#1. For the floor in Café Nook 101, where should changes in floor finishes occur? Please provide finish floor plan for Café Nook 101 showing flooring transitions.

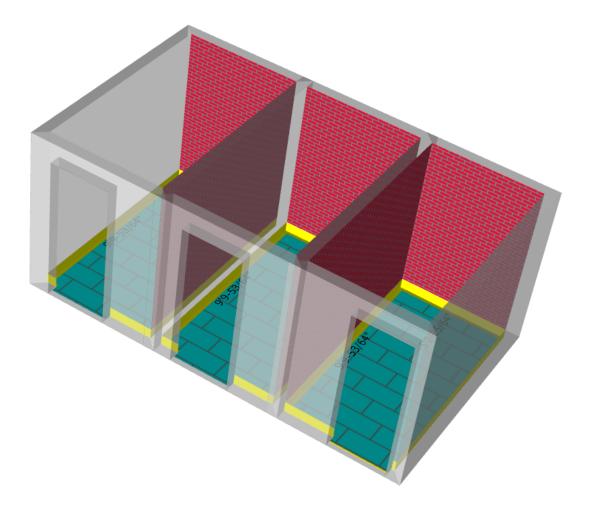
#2. Finish #3 calls for wall tile on "Kitchen Wall." .Please specify walls to receive tile in kitchen area. PLEASE SEE ATTACHED SKETCH 01.

## PLEASE SEE ATTACHED SKETCH 01.
